MFN No. 066-91
Docket No. STN 50-605
EEN-9144

Subject: GE Responses to Discussion Items from Conference Calls of June 3
1991 and June 5, 1991 with Plant Systems Branch

PLANT SYSTEMS OPEN ITEMS FOR DISCUSSION

Figure 9.2-6a TURBINE COOLING WATER SYSTEM DIAGRAM

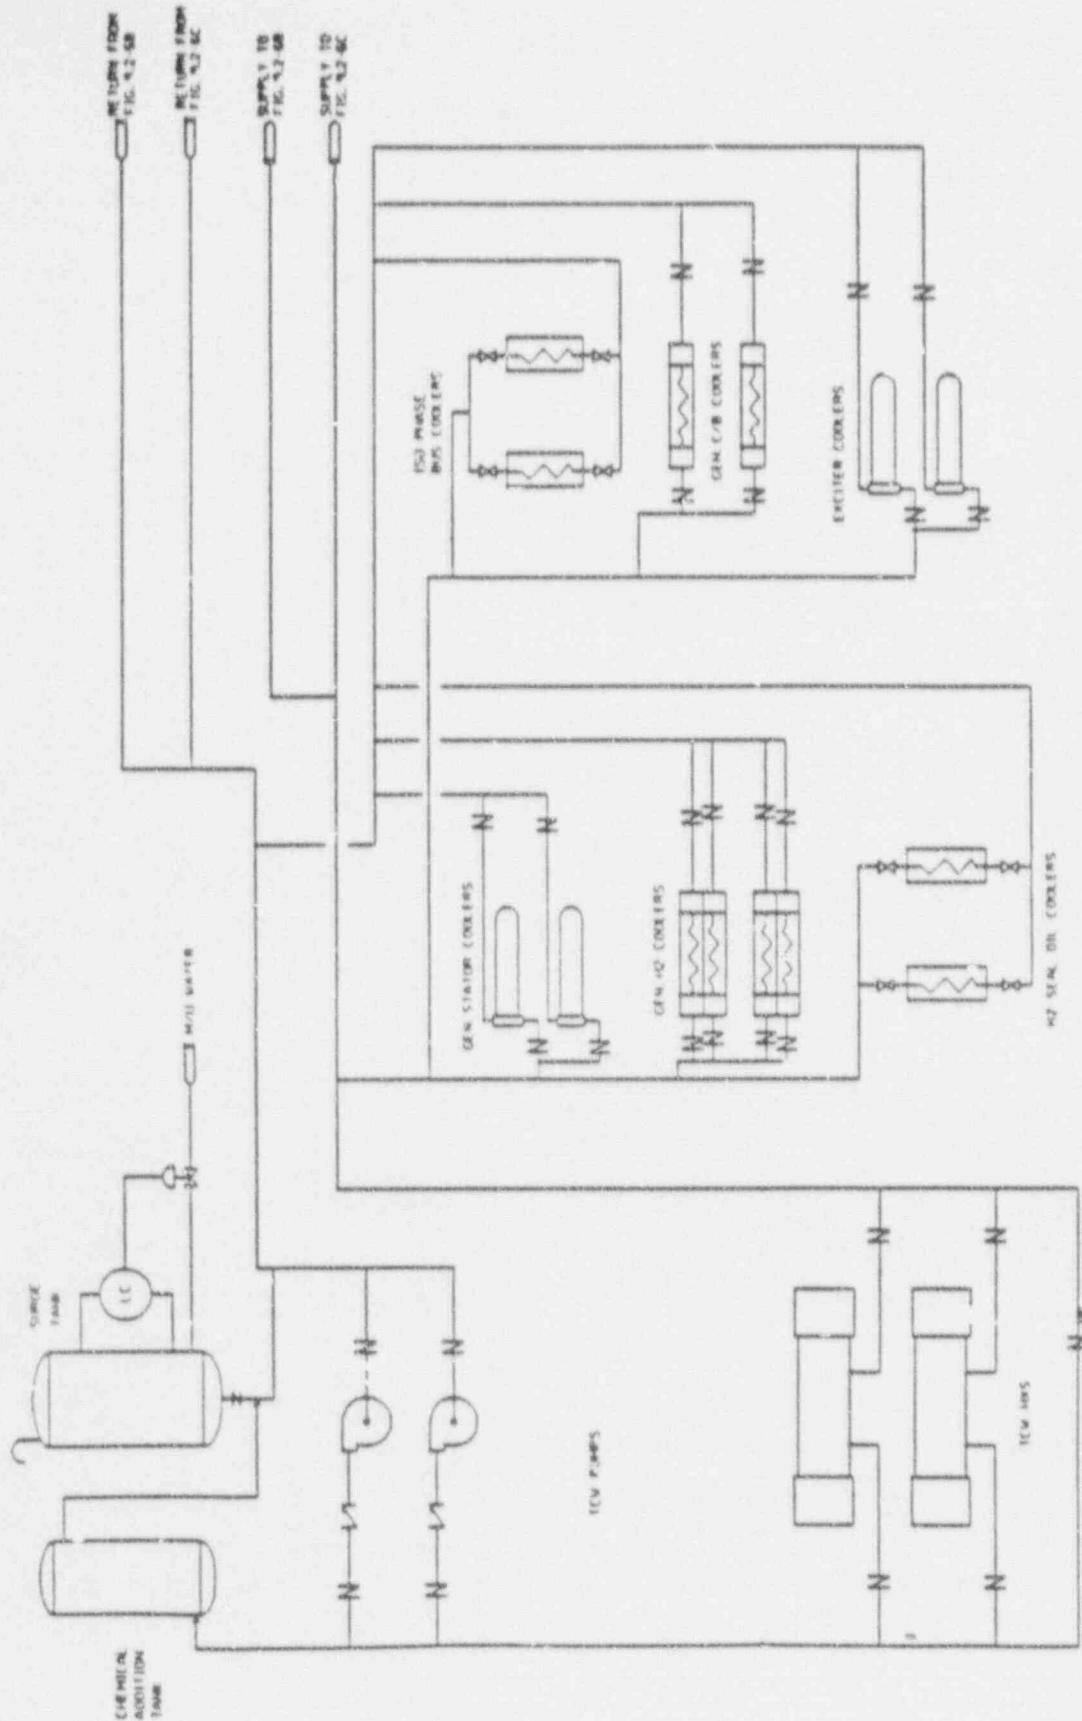
The TCW system is a non-safety related system designed to provide heat removal capability for various turbine island auxiliary equipment. The TCW is a closed loop system consisting of two 100% pumps, two 100% heat exchangers, a surge tank and associated piping, valves and instrumentation. The description of the TCW in this section of the ABWR SSAR contains several inconsistencies. The component and system descriptions of Section 9.2.14.2.3 "System Operation" and of Figure 9.2-6a do not agree with the descriptions of Sections 9.2.14.2.1 "General Description" and 9.2.14.2.2 "Component Description" and the responses to RAIs. The discrepancies (number of heat exchangers, pump capacities) should be corrected. Because the descriptions in Sections 9.2.14.2.1 and 2 are more recent versions of the system description, they were analyzed as the TCW system. These discrepancies remain an open item.

Response to this open item is provided in revised Subsection 9.2.14.2.3 (pages 9.2-10.1 and 9.2-11) and revised Figure 9.2-6a (page 9.2-42).
